CHRYSLER A604 (41TE) UPDATE HANDBOOK

**AUTOMATIC TRANSMISSION SERVICE GROUP
9200 S. DADELAND BLVD. SUITE 720
MIAMI, FLORIDA 33156
(305) 670-4161**

"UPDATE HANDBOOK"

Figure 15

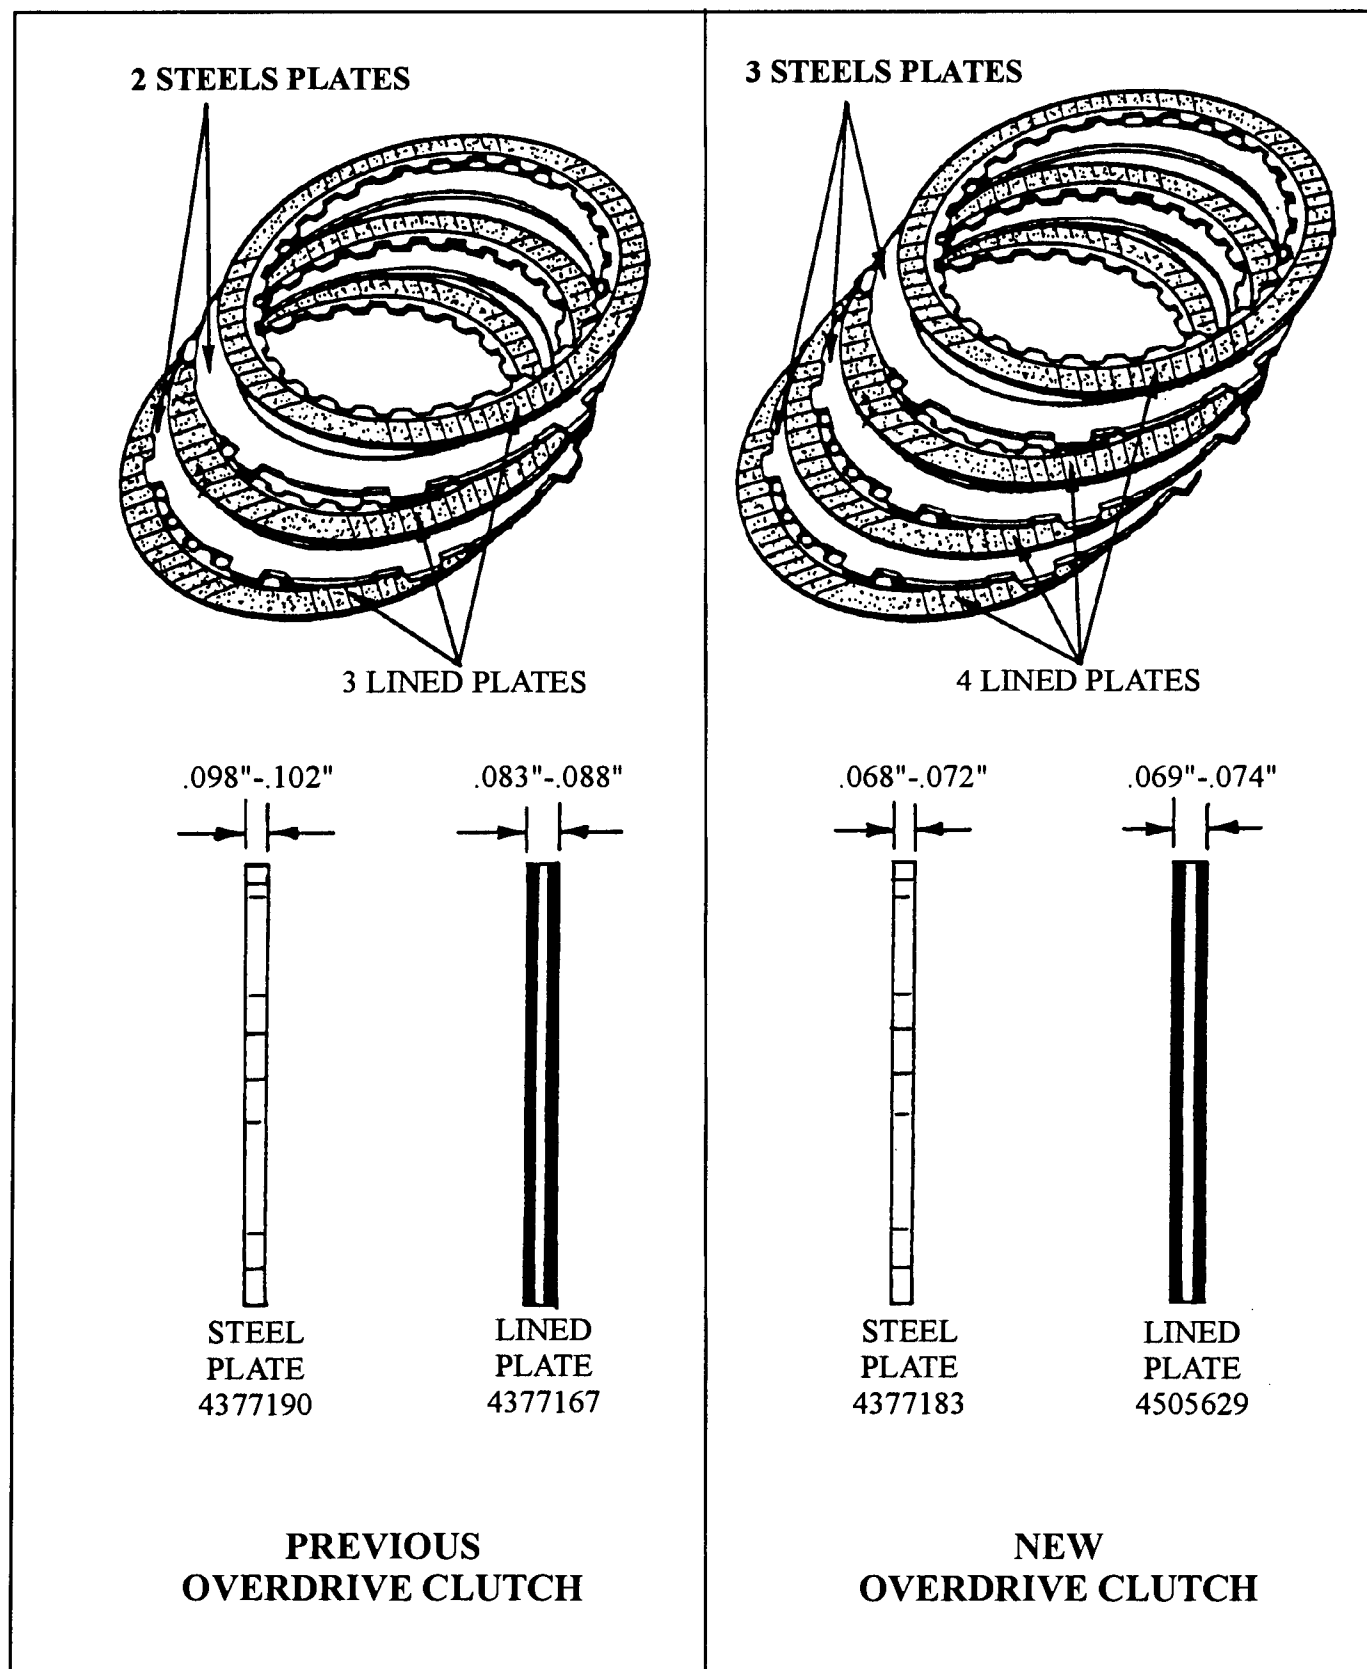
CHANGE: A running change for 1990 model A604 transaxles was the introduction of a four (4) disc Overdrive Clutch Assembly, to replace the previous three (3) disc clutch assembly (See Figure 15).

- (1) **OVERDRIVE LINED PLATES** - Now uses 4 lined plates instead of the previous 3 lined plates, and the lined plates for 1990 models are .014" thinner than the 1989 lined plates (See Figure 15), to help accommodate the extra lined plate. The 1989 lined plates measure .083"-.088" thick, and the new lined plates will measure .069"-.074" thick (See Figure 15).

- (2) **OVERDRIVE STEEL PLATES** - Now uses 3 steel plates instead of the previous 2 steel plates. The new steel plates are .030" thinner, and measure .068"-.072" thick. The previous steel plates measure .098"-.102" thick (See Figure 15).

Figure 16

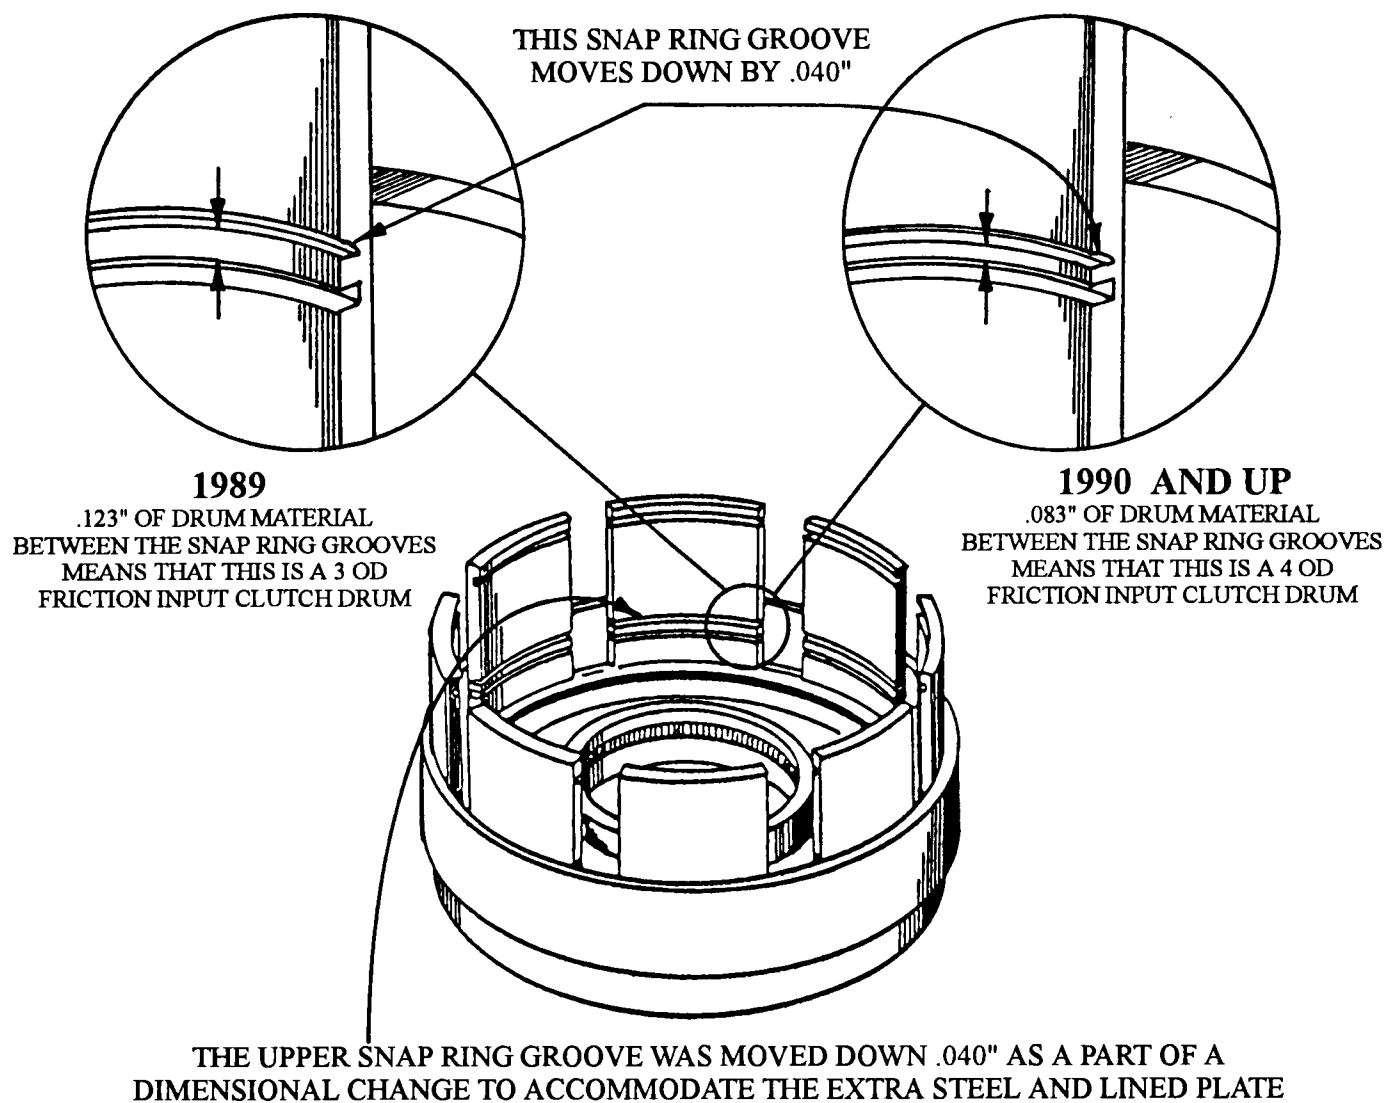
- (3) **INPUT CLUTCH RETAINER** - The underdrive/overdrive reaction plate tapered snap ring groove was moved "Down" by .040" (Can be detected visually) to make room for the added lined and steel plates (See Figure 16). This also necessitated a change to be made to the underdrive/overdrive reaction plate as explained below. Another change that occurred at the same time is the underdrive clutch outer lip seal groove depth is .040" "Shallower" to accommodate a new underdrive clutch outer lip seal (See Figure 17).

Figure 17

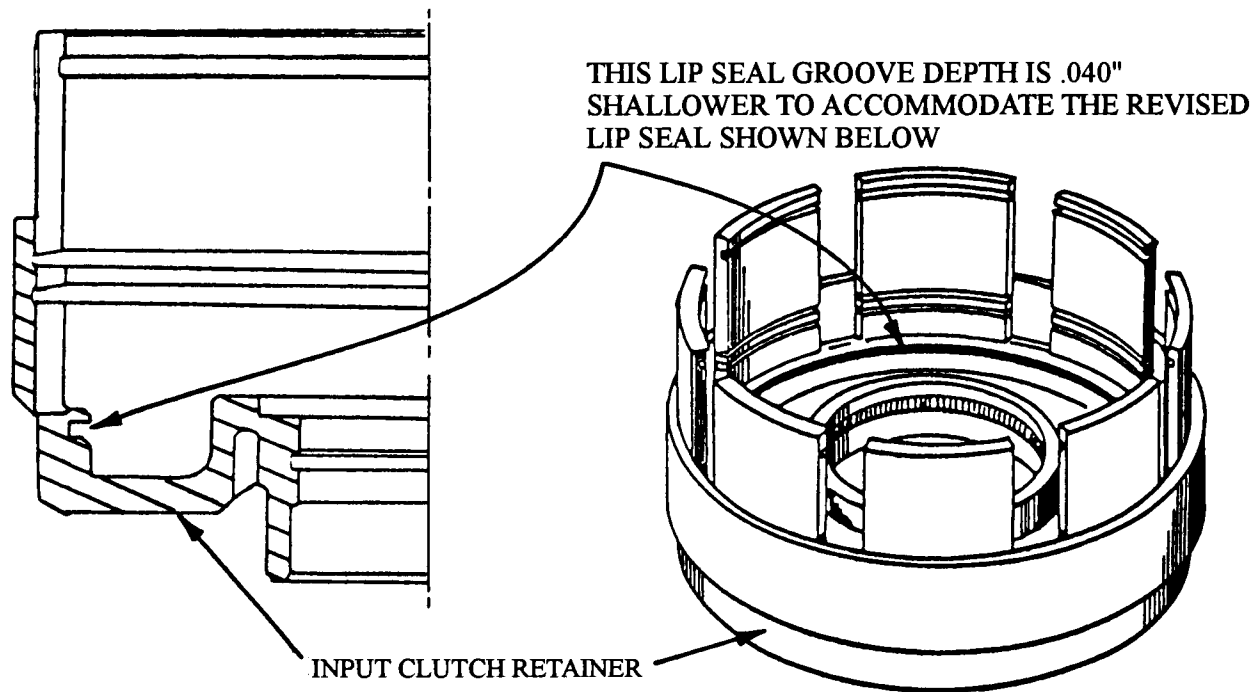
- (4) **UNDERDRIVE CLUTCH OUTER LIP SEAL** - The lip seal cross section has been reduced by .040" (Smaller in Overall Diameter) to accommodate the change in the depth of the groove in the input clutch retainer (See Figure 17). The OEM part number is printed on the seals for identification. The 1989 (Large) is 4377173, and the 1990 (Small) is 4531408. This will confirm that you have the proper seal for this location (See Figure 17).

Figure 21

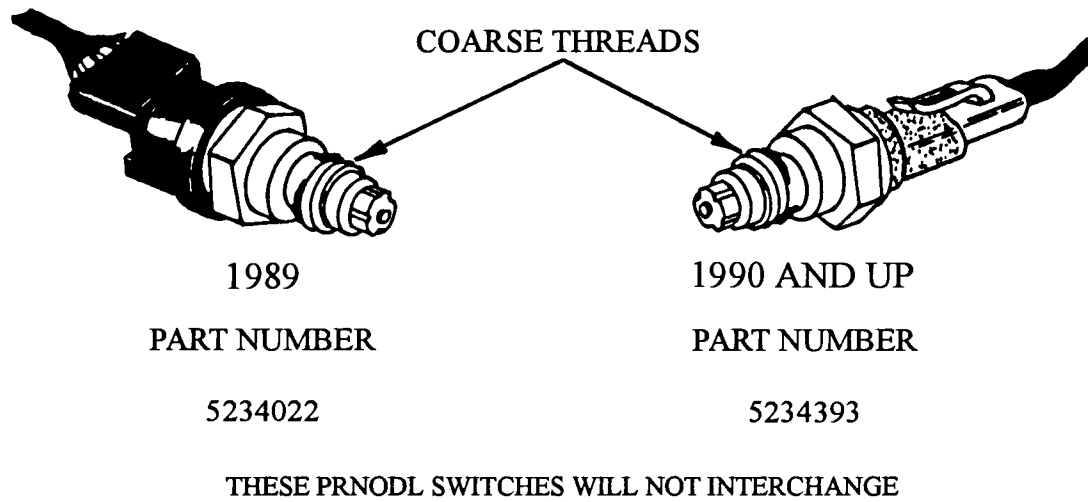
- (1) **PRNODL SWITCH AND CONNECTOR** - The PRNODL Switch and its wiring harness connector have changed for 1990, and can be identified visually (See Figure 21). These PRNODL Switches WILL NOT interchange with one another.
- (2) **NEUTRAL SAFETY SWITCH AND CONNECTOR** - The Neutral Safety Switch and its wiring harness connector have changed for 1990, and can be identified visually (See Figure 22). These Neutral Safety Switches WILL NOT interchange with one another.

Figure 28

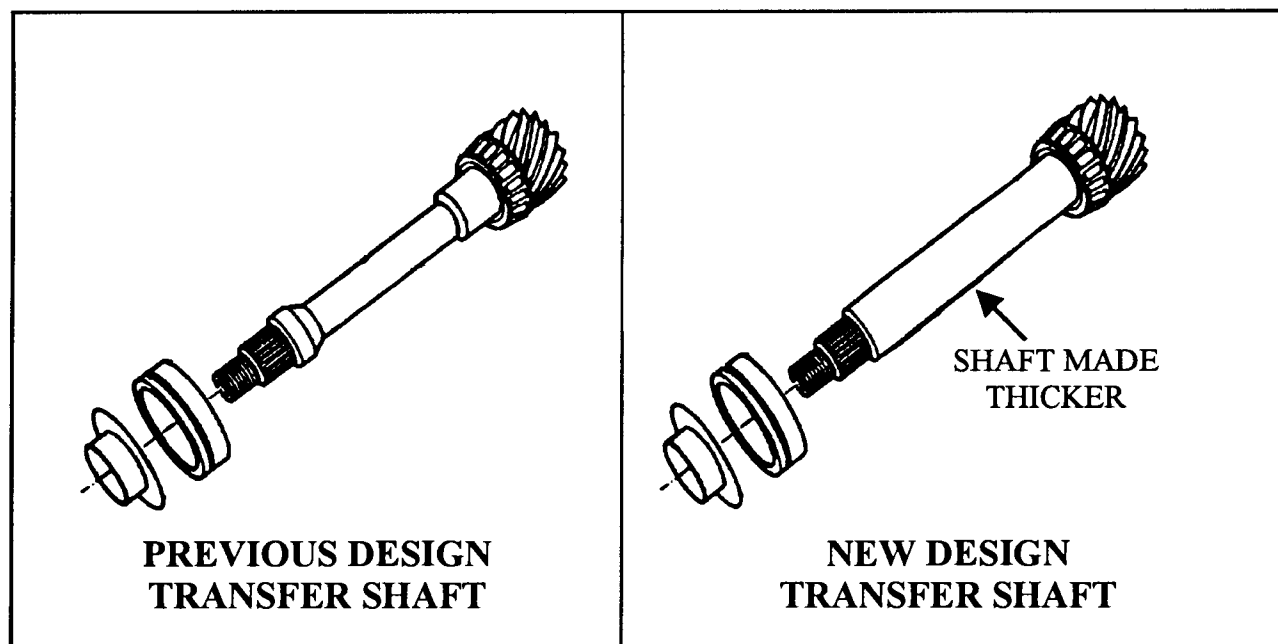
CHANGE: A thicker transfer shaft was made as a running change in 1990 and continues through to current production (See Figure 28).

- (1) **TRANSFER SHAFT** - The transfer shaft between the transfer gear end and the threaded end of the shaft increased in diameter to accommodate torque transfer (See Figure 28).

Figure 29

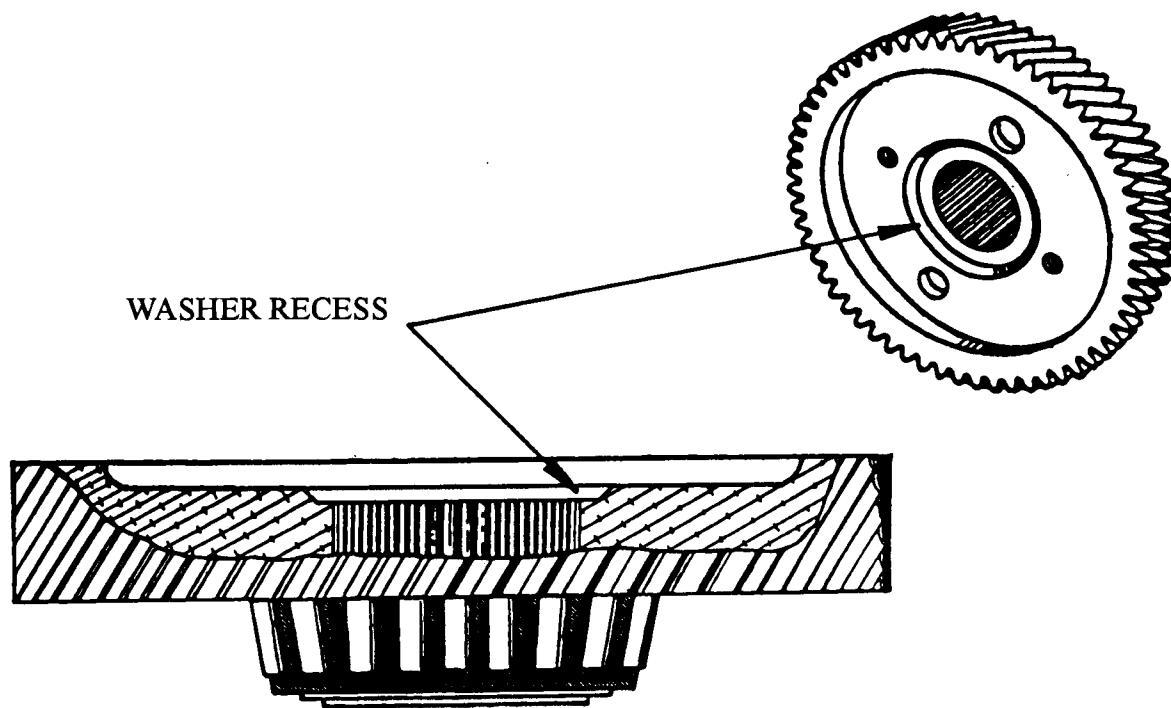
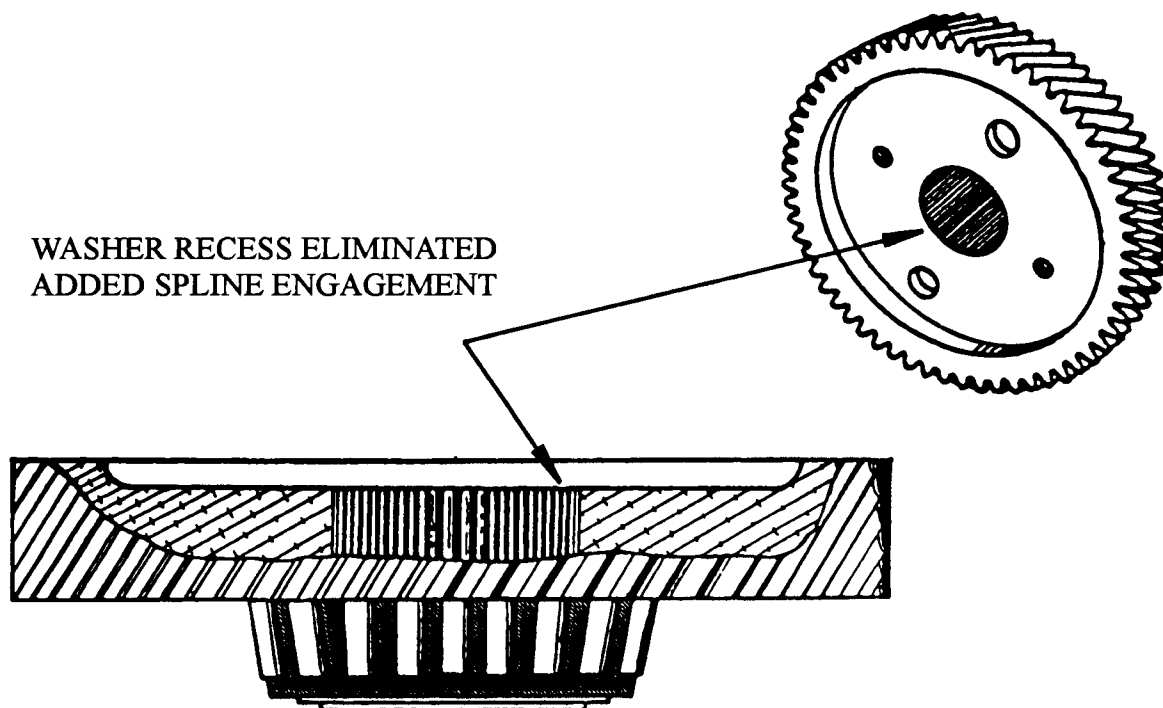
- (1) **TRANSFER GEARS** - The helix angle of the teeth on both transfer gears changed from 27.5 degrees to 32 degrees. The new design transfer gears can be easily identified by the removal of the washer recess area in the center of the gears, as shown in Figure 29. This was done to create more spline engagement, to accommodate higher torque engines.

Figure 33

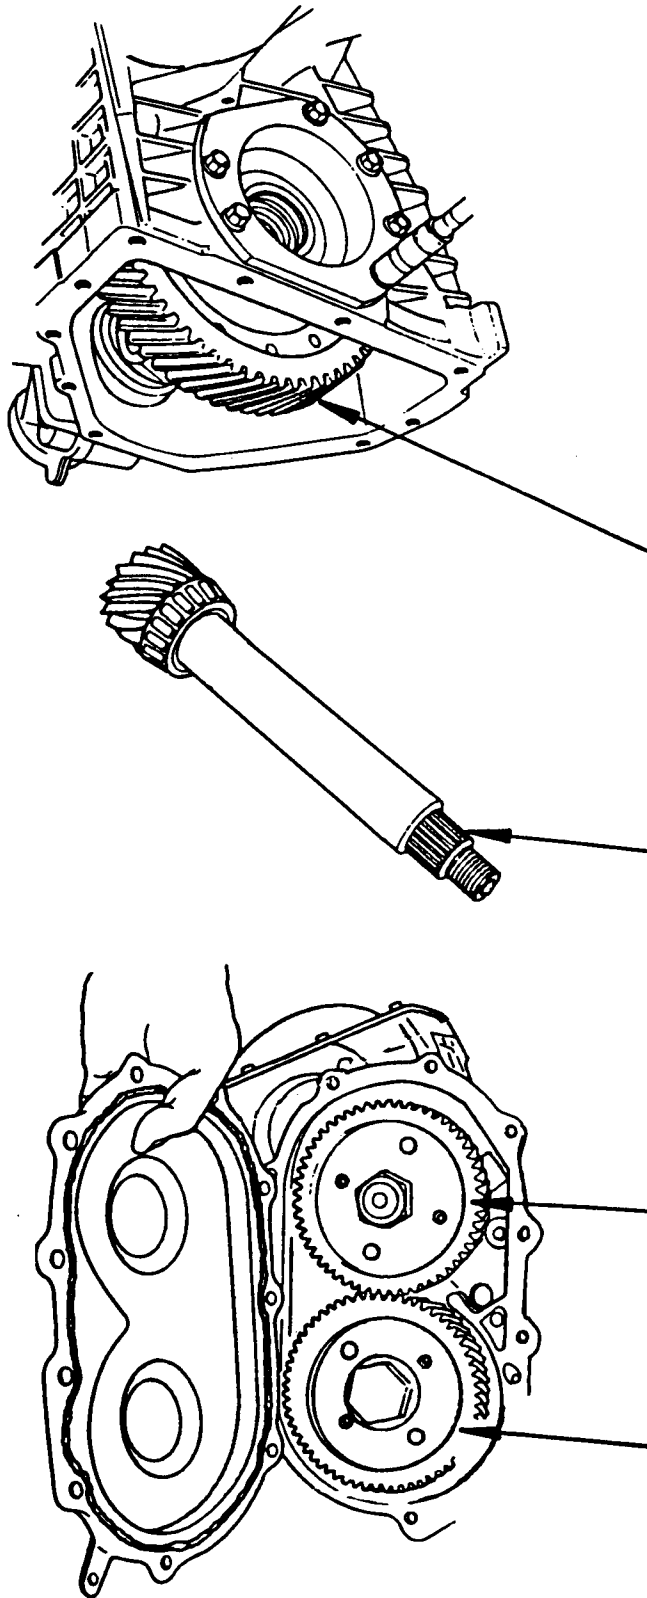
- (6) **OVERALL GEAR RATIO** - New gear ratios come with the upgrade to the 32 degree transfer gears (See Figure 33).
